Product Change Notification

December, 2016

Bourns® Model FB2000 Series Wide-Band Chokes Change to Core Design

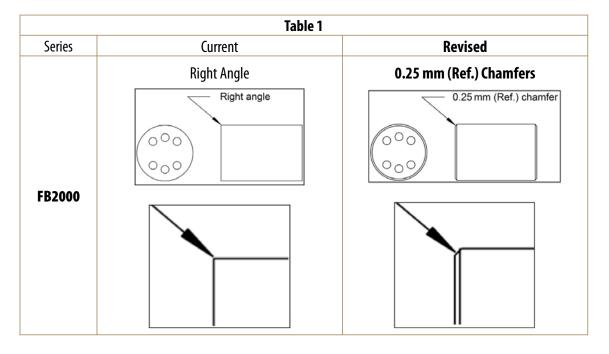
Bourns has changed the core design of the Model FB2000 Series Wide-Band Chokes starting with the manufacturing date code 1629. Chamfers are included at both ends of the core to reduce the possibility of material chipping during production assembly. See Table 1 for details.

This core modification will not affect the form, fit or function of the wide-band choke. However, the quality and reliability of the component should be enhanced.
